**PLAN COMMISSION / ZONING BOARD OF APPEALS  
AGENDA**

**Project:** Sparks Coffee Co. – New Construction  
**Meeting Type:** Public Hearing  
**Request:** Major change to PUD, Special Use Permits (4)  
**Location:** Hickory Creek Marketplace, Outlot 1E  
**Applicant:** Aliana Winkle  
**Prop. Owner:** Winkle R E Properties  
**Representative:** Applicant  
**Staff report by:** Christopher Gruba, Senior Planner

## **Major changes to plans since workshop**

4 NORTH ELEVATION  
1/4" = 1'-0"

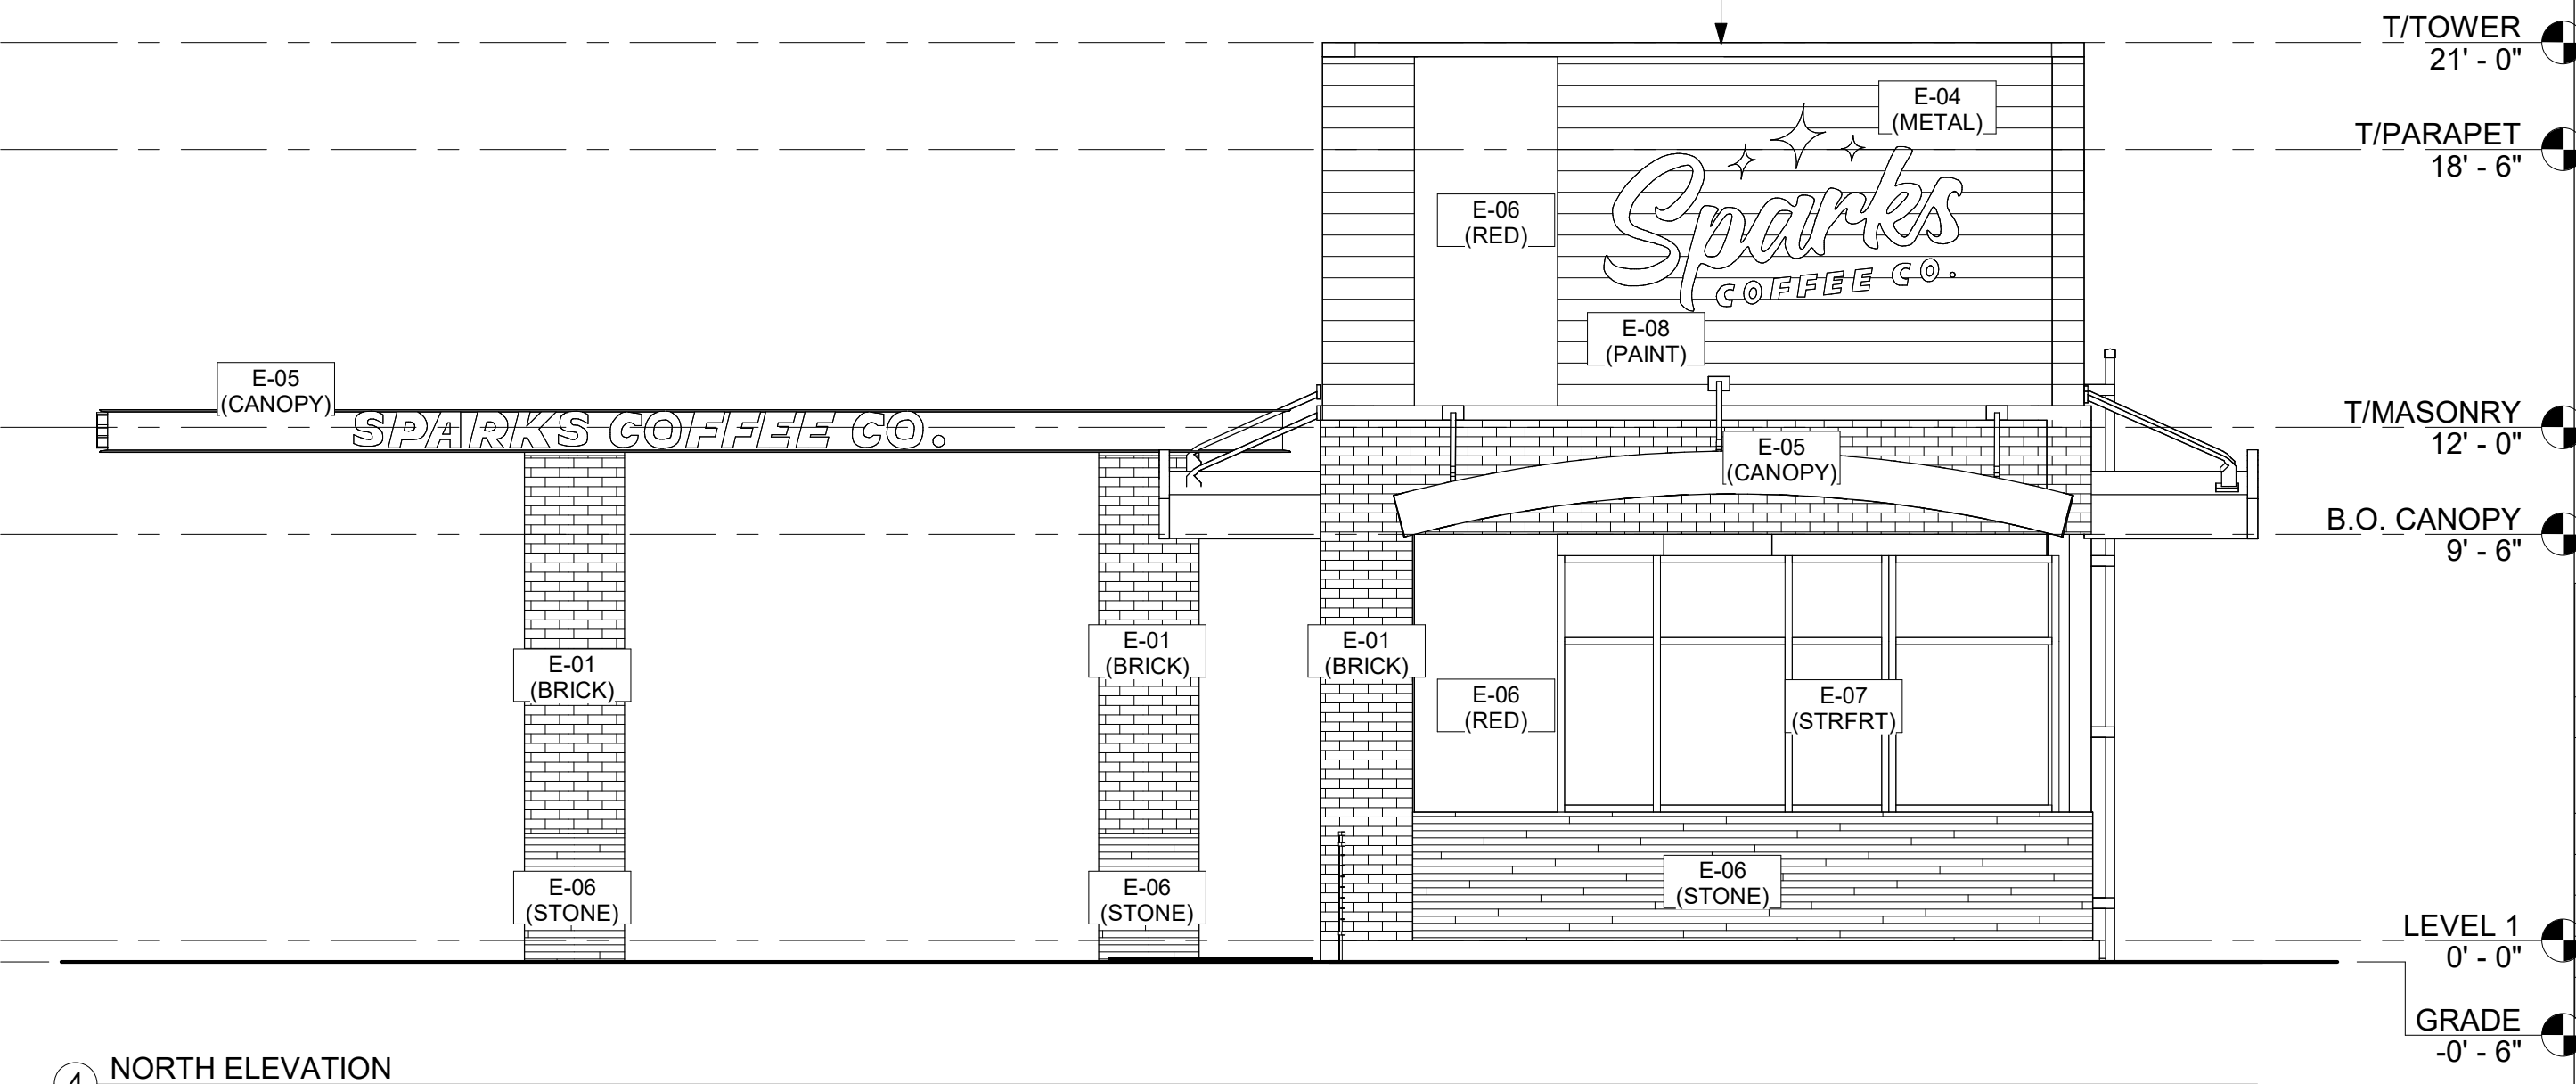
5. A roof access ladder is attached to the west of the building facing La Grange Road.
6. Historically, the Village has not permitted the use of thin brick on buildings. Sheet A300 notes the use of thin brick. Consistent with other recent commercial projects, staff recommends that the Plan Commission/Zoning Board of Appeals condition any approval on the use of standard dimensional brick.

4. Recommend to the Village Board to approve the Major Change to a PUD, in accordance with the reviewed plans and public testimony, conditioned on final engineering approval, using standard brick instead of thin brick on the building and the following exceptions:
